SUBJECT: DRAFT SAFETY EVALUATION FOR PRESSURIZED WATER REACTOR
(PWR) OWNERS GROUP (PWROG) TOPICAL REPORT (TR)
WCAP-16793-NP, REVISION 0, "EVALUATION OF LONG-TERM COOLING
CONSIDERING PARTICULATE, FIBROUS AND CHEMICAL DEBRIS IN THE
RECIRCULATING FLUID" (TAC NO. MD5891)

1 DRAFT SAFETY EVALUATION BY THE OFFICE OF NUCLEAR REACTOR REGULATION

2
3 TOPICAL REPORT WCAP-16793-NP, REVISION 0

8
9 PRESSURIZED WATER REACTOR OWNERS GROUP

25
26
27
Figure 1
Schematic of Fuel Assembly Fibrous Debris Capture Test Loop

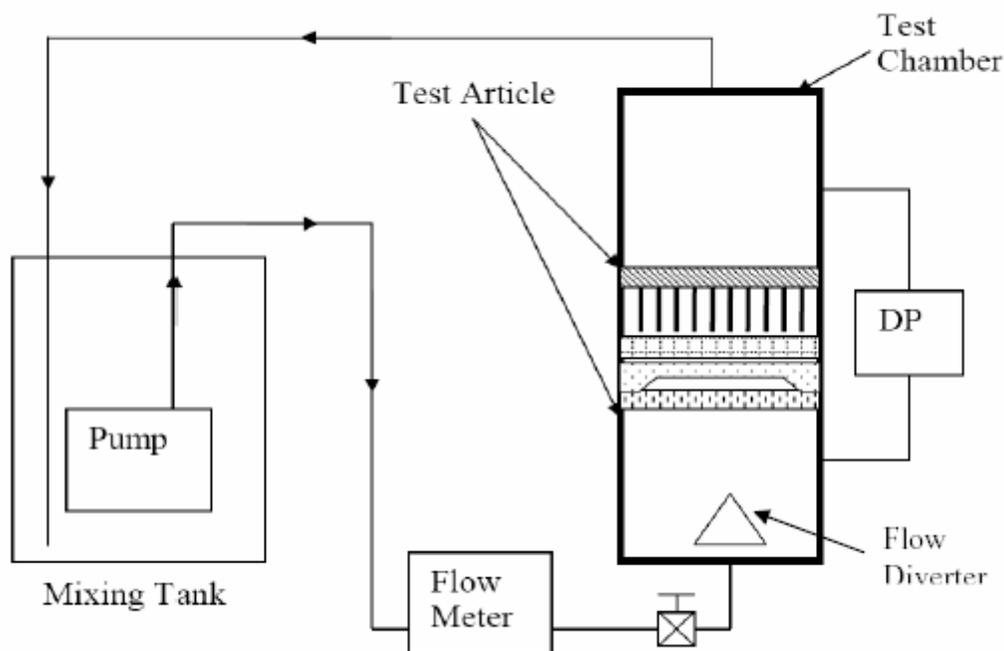
32
33 The type, amounts, and characteristics of the fiber and particulate matter were not described in
34 Reference 6. The specific flow velocities that existed in the mock up fuel bundle inlet were not
35 given nor were the resulting pressure drop. In order for a licensee to relate a postulated
36 post-LOCA core inlet debris bed to the tests described in Reference 6, this information was
37 needed. In response to an RAI from the NRC staff, the PWROG provided, in Reference 3,
38 additional test details and description as follows:

44 A schematic of the test loop is shown in Figure 1, below. Test instrumentation consisted of
45 differential pressure measurement across the test bundle. The test bundle consisted of the
46 simulated core support plate, bottom nozzle, debris-capturing guardian grid, an intermediate
47 support grid, simulated fuel rods (3/8-inch plastic rod) with simulated control rods, and an upper
48 support grid.

Figure 2
Head Loss versus Debris Mass

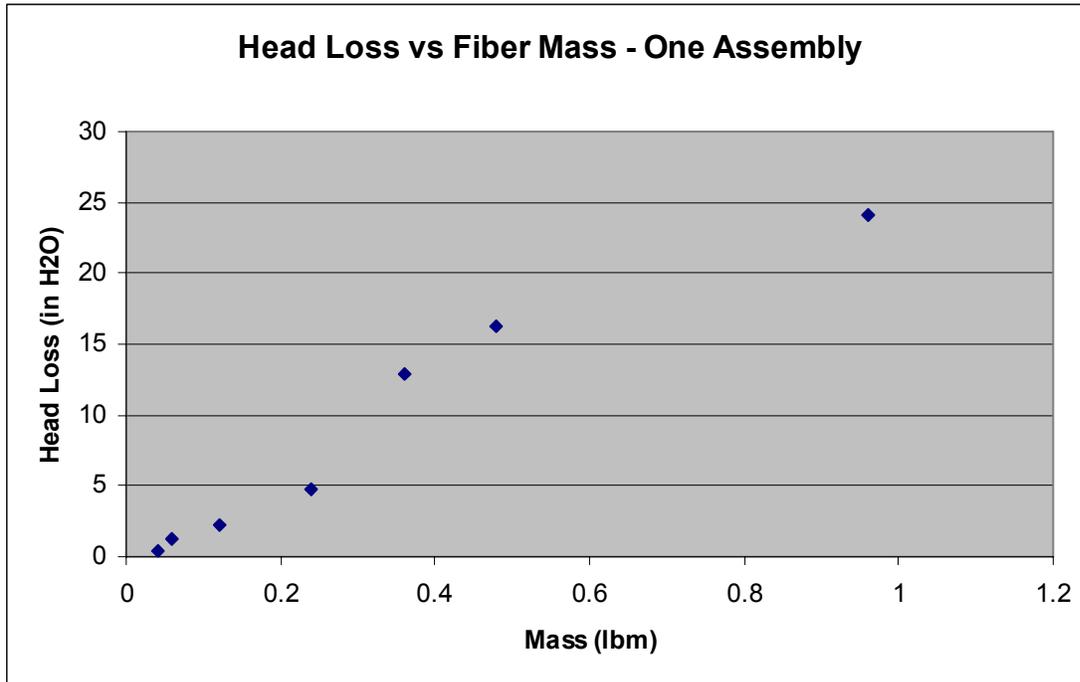
13 Measured head loss as a function of the fiber mass of debris for one fuel assembly for the tests
14 is shown in Figure 2. The PWROG stated in Reference 3, that a bounding head loss, based on
15 tests performed assuming collection of 21.7 ft³ of fibrous debris and 1388.8 lbm of particulate
16 debris at the entrance to the core, would be expected to be about 10.2 inches of water, or an
17 increase in pressure drop of 0.37 psi at the core inlet. The NRC staff did not review the test
18 results in detail but believes them to be reasonable because of the observation of little debris
19 capture on the fuel inlet grid. It was further noted that the WCAP-16793, Appendix B,
20 WCOBRA/TRAC bounding analysis, with an assumed flow blockage of 99.4 percent,
21 demonstrated adequate flow rate to remove decay heat. A flow blockage of 99.4 percent would
22 result in a head loss substantially greater than 10.2 inches of water. Thus, a plant with a

23 calculated head loss of 10.2 inches of water would be bounded by the TR results and would be
24 able to conclude it would have adequate core cooling.
